TO: Town of Haymarket Planning Commission
SUBJECT: Haymarket Ice Rink - Preliminary Site Plan
DATE: 09/09/13

SUBJECT: HAYMARKET ICE RINK PRELIMINARY PLAN 3RD SUBMISSION COMMENTS

RE: Haymarket Ice Rink Expansion
Preliminary Site Plan PRE20130415 Second Submission
ccl Project #: 09090.005.00

HAYMARKET ICE RINK EXPANSION PRELIMINARY SITE PLAN

COVER SHEET

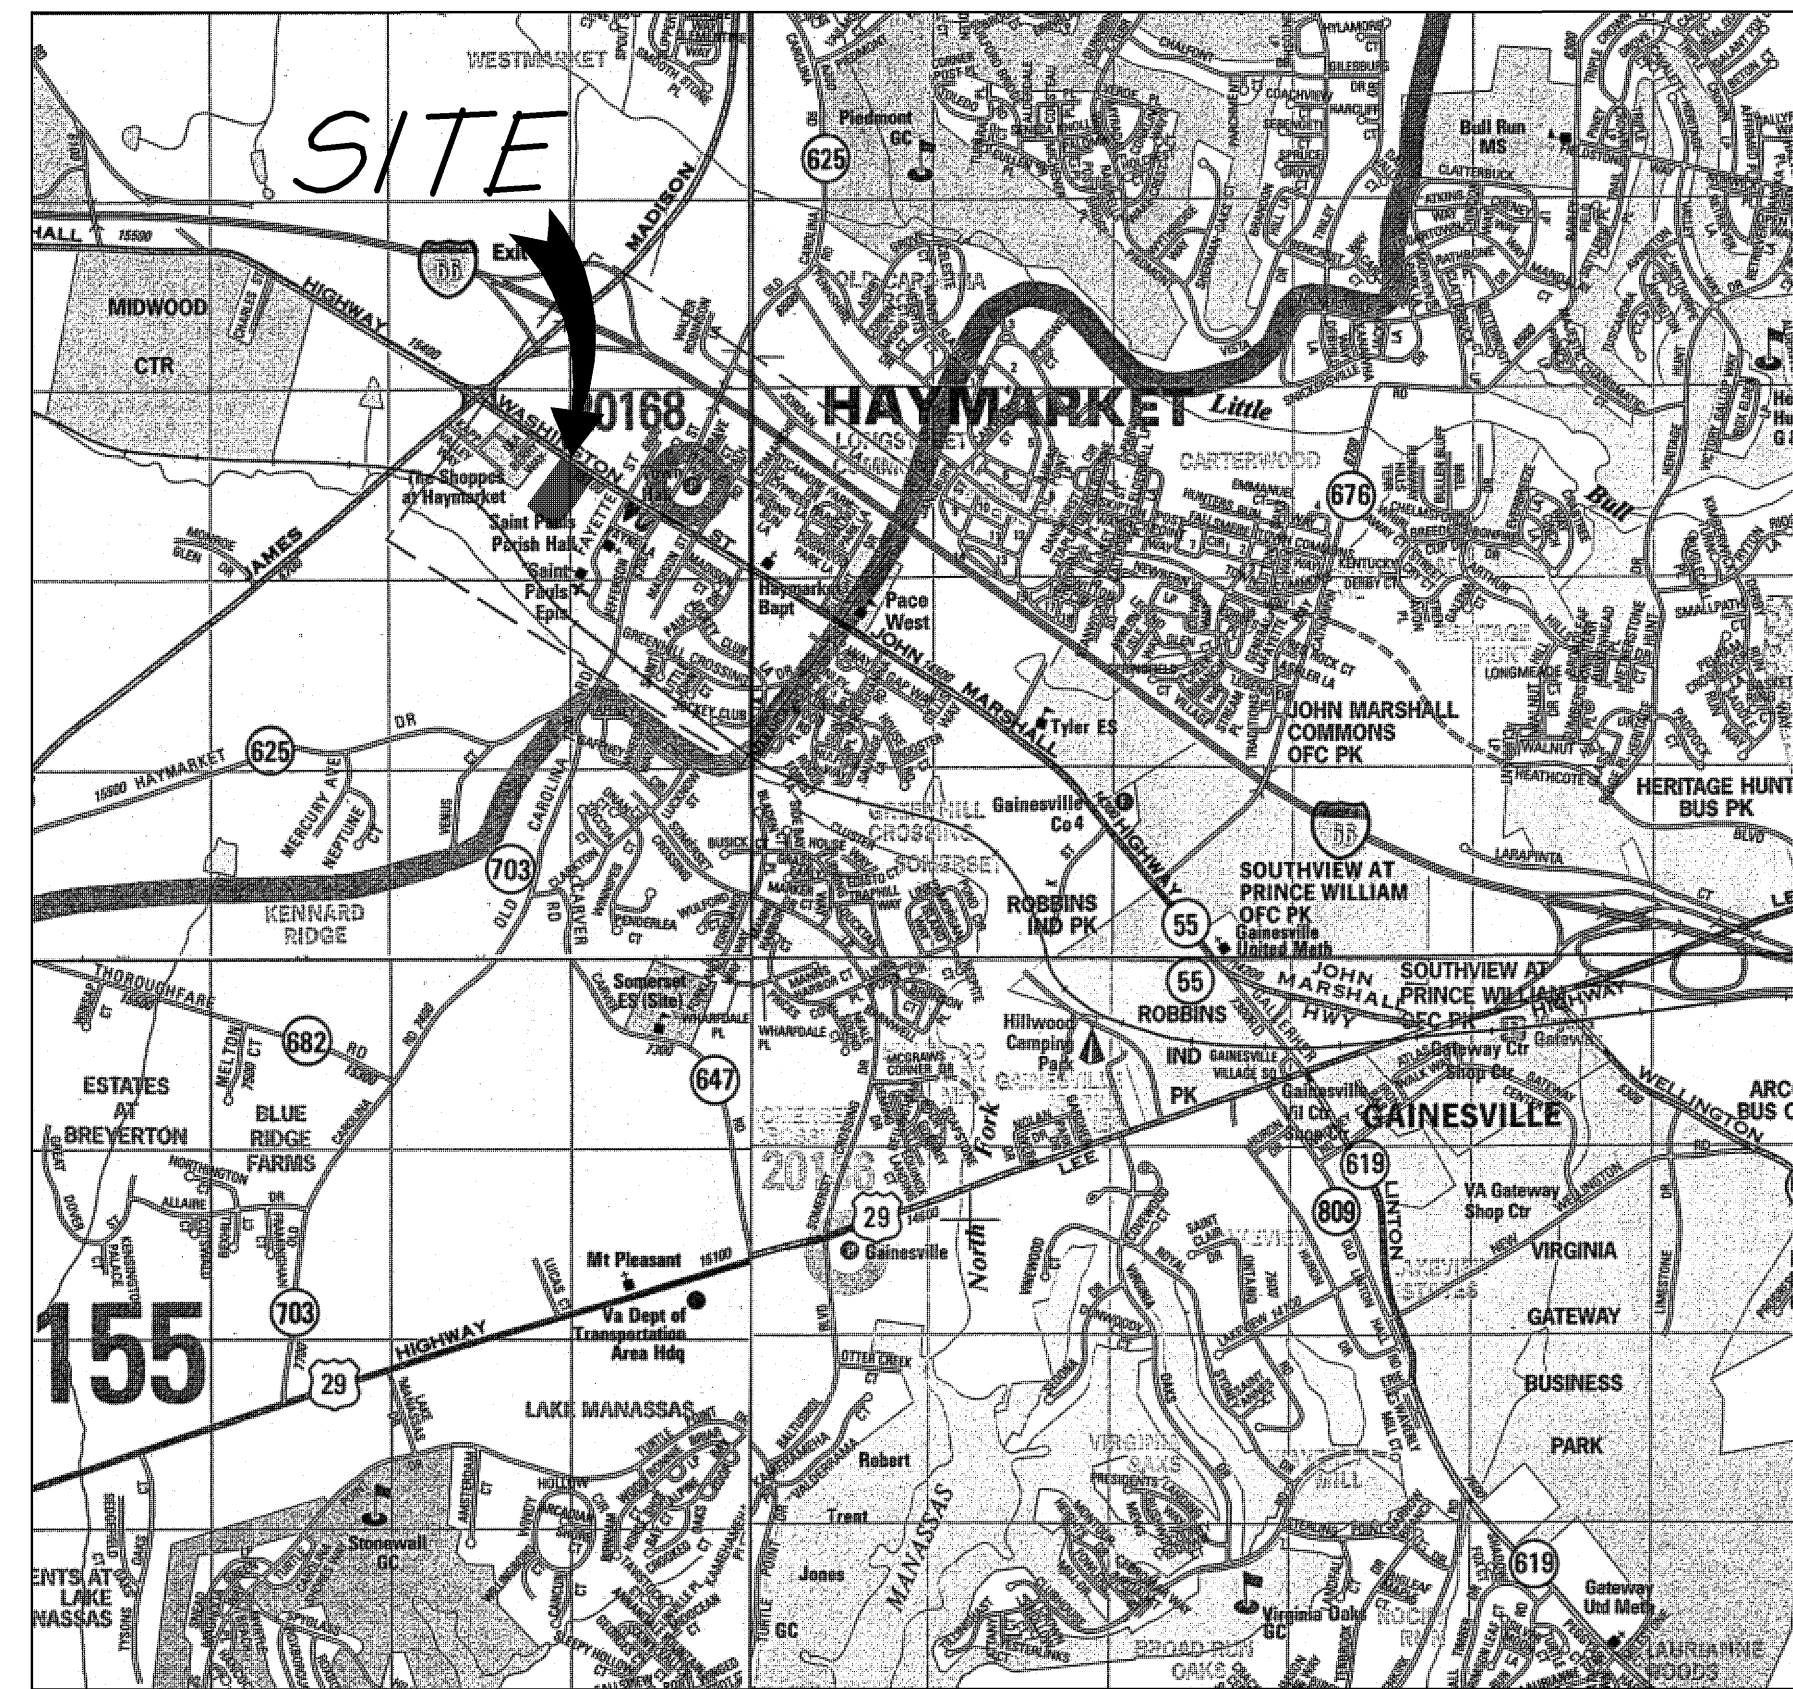
- 1. Provide property address.

- 2. Add "Expansion" to "Haymarket Ice Rink" in the title block consistent with Sheet 2.

- 3. Zoning Tabulations – buffer to R-1 Zone should state the modified buffer is requested as part of the preliminary plan and reference the corresponding landscape plan sheet (see Sheet 11 of Haymarket Ice Rink Final Site Plan).

Response: The property address has been added to the cover sheet

Response: "Expansion" has been added to the title block, consistent with Sheet 2.

Response: A note has been added to the cover sheet stating the modifier buffer to R-1 is requested as part of this plan.

PRELIMINARY
 SITE PLAN

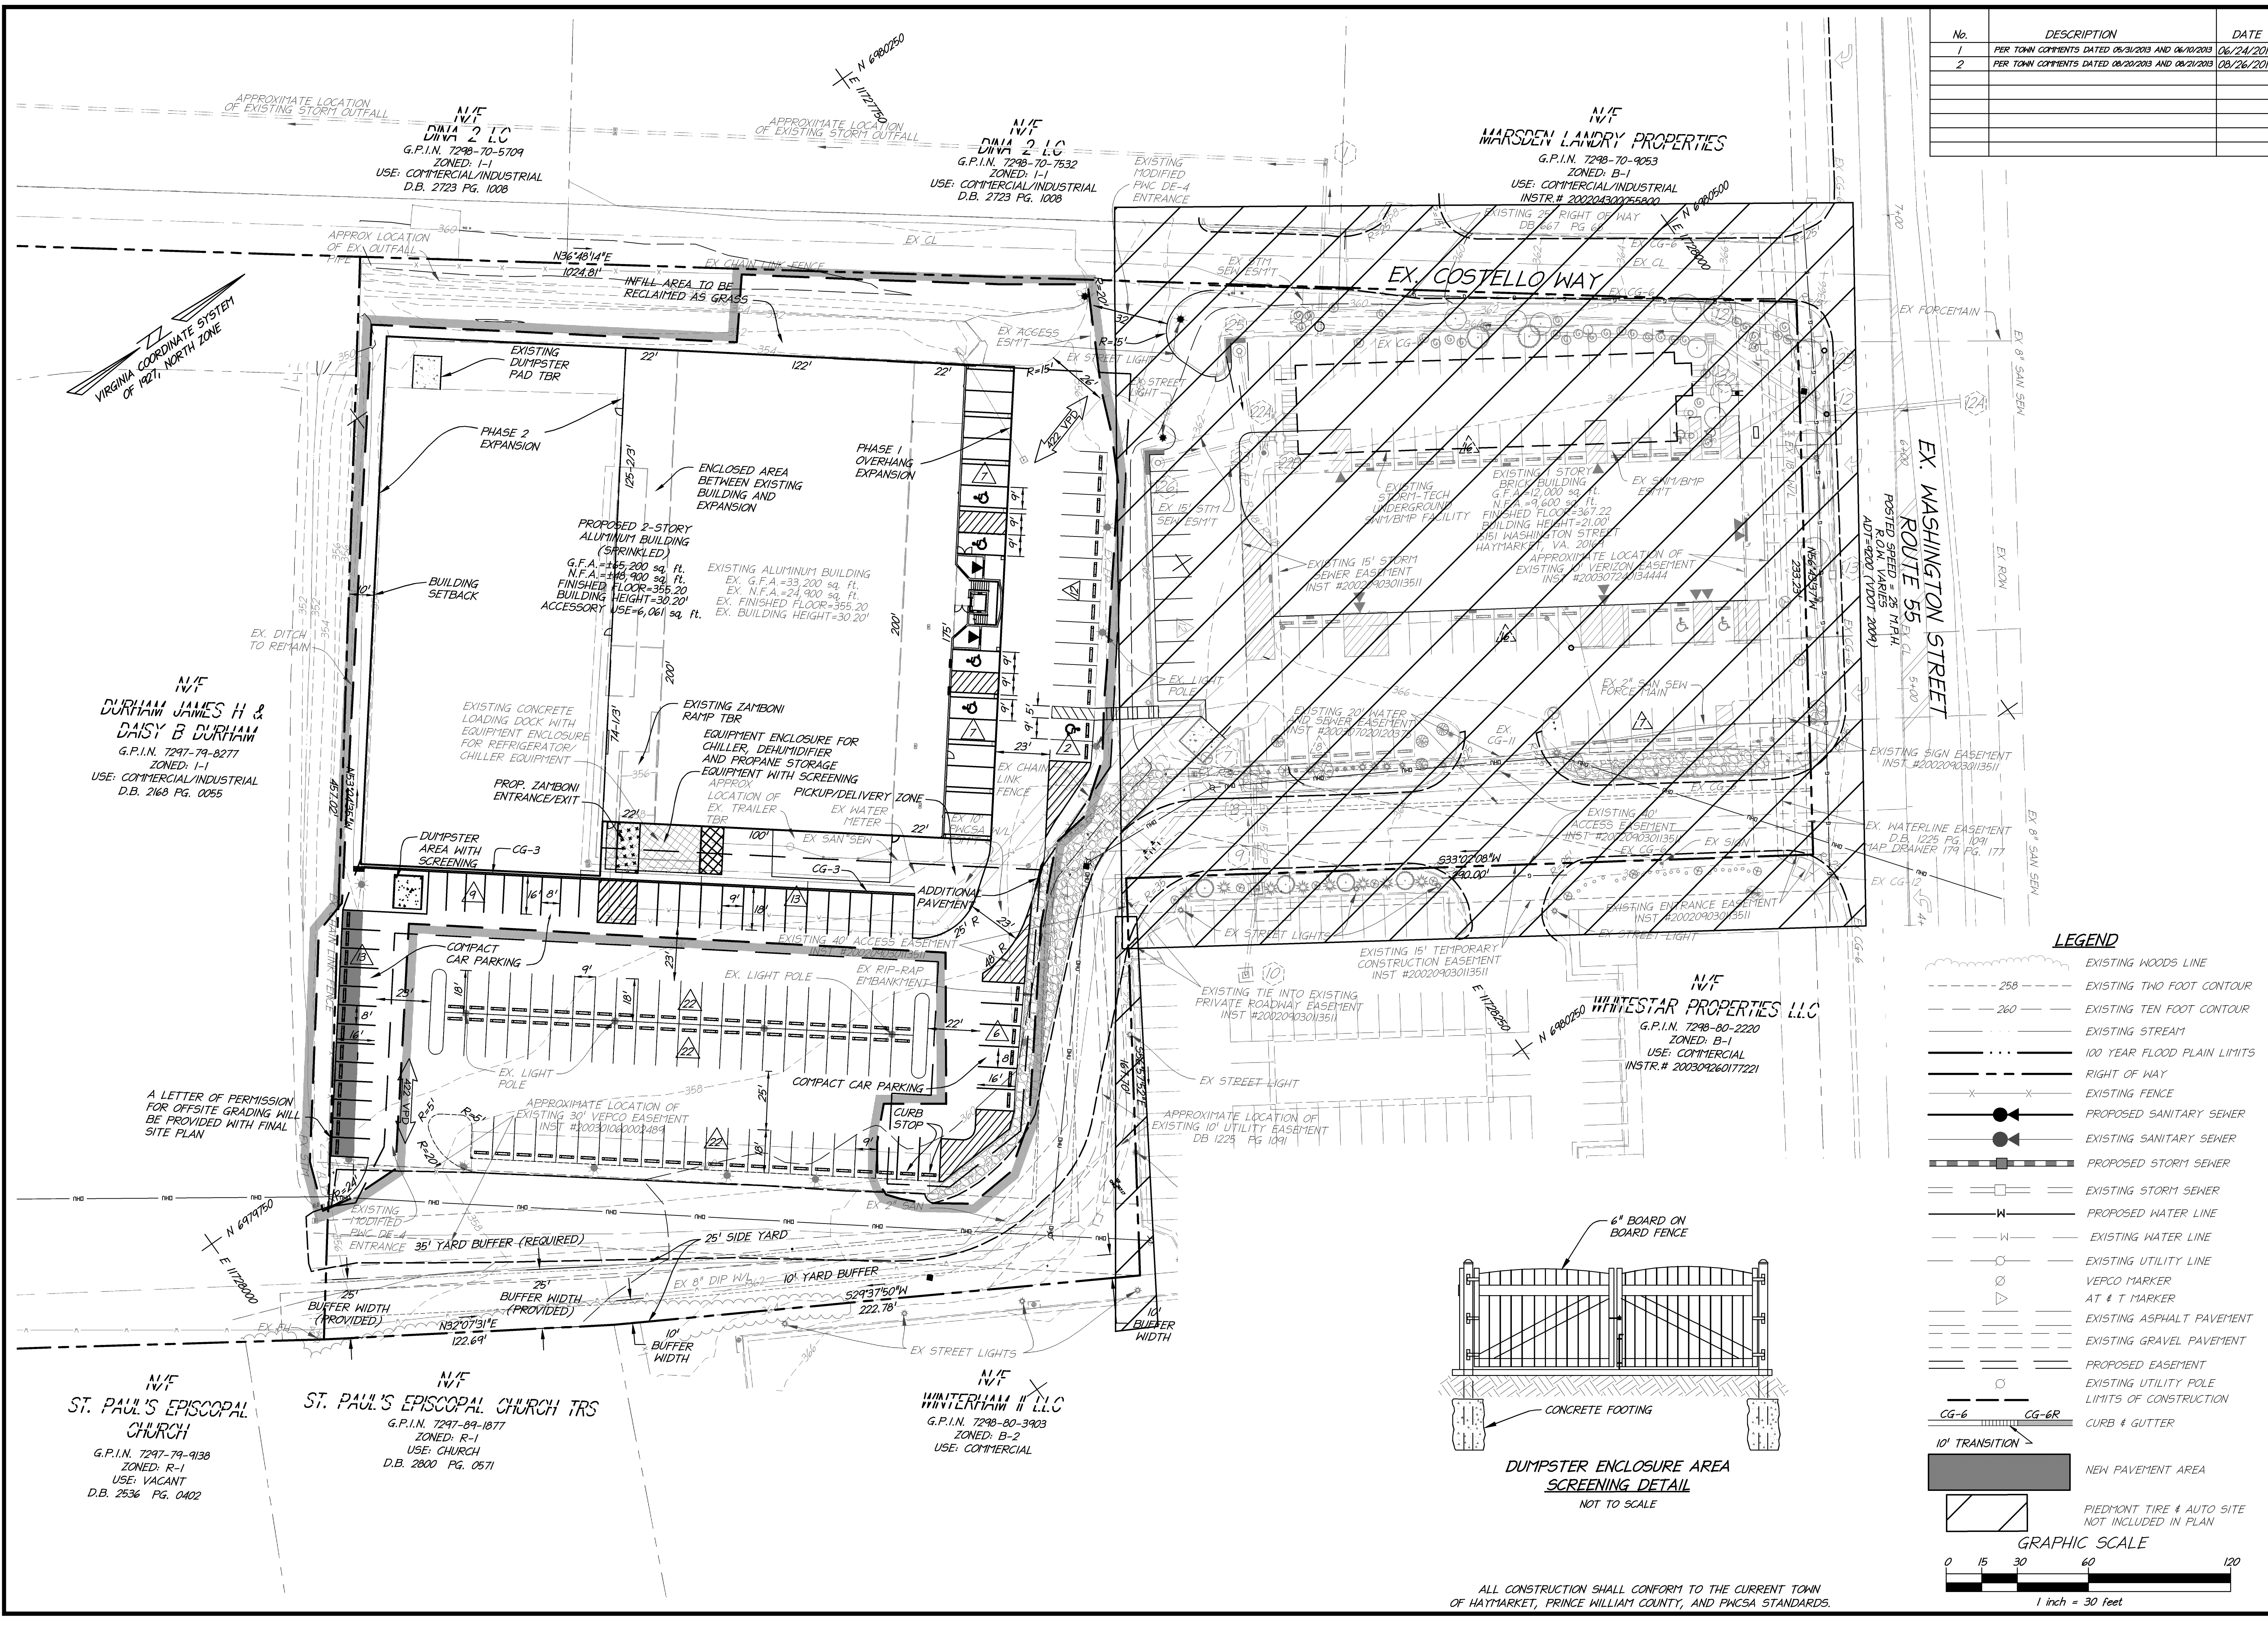
9. Per Section 58-701(e), outdoor storage areas are to be screened. Show and/or provide screening detail for the following items:
- Dumpster Area (also indicate existing dumpster area is to be removed).
 - Equipment enclosure for the chillers on the east side of the building (currently plywood)
 - Propane storage on east side of building
 - Dehumidifier on east side of building
 - Any new equipment areas associated with the second rink.

Status: Existing propane storage and the dehumidifier are located outside the noted enclosure area. The Final Site Plan should ensure all equipment associated with both rinks can be enclosed within the required screen. Also, a screen detail should be provided with the Final Site Plan. Lastly, the detail for the dumpster enclosure shows a board on board wood gate. A similar gate structure was used for dumpster enclosure at the auto repair facility. The gate was unserviceable within a few months of construction. A more durable gate enclosure should be detailed with the submission of the Final Site Plan.

Status: A pickup and delivery zone for patrons of the ice rinks has not been identified on the site plan pursuant to 58-257(16)(C). It is suggested an area be located near the rink entrance which does not impede traffic flow through the site.

Status: It is suggested portions of these areas be used to recapture some or all the landscape islands and/or open space lost with the addition of the second rink as part of the Final Site Plan submission.

Final Response: The proposed enclosure area has been expanded and will be adequately sized on the final site plan to accommodate all equipment for both rinks. The dumpster gate detail will be changed to a more durable type of enclosure on the final site plan.

Final Response: A pickup/delivery zone has been designated in an area that will not impede traffic flow as shown on plan sheet 02.

Final Response: This area is being used as the pickup/delivery area, but the viability of using portions of this area to recapture parking lot landscaping will be evaluated with the Final Site Plan Submission.
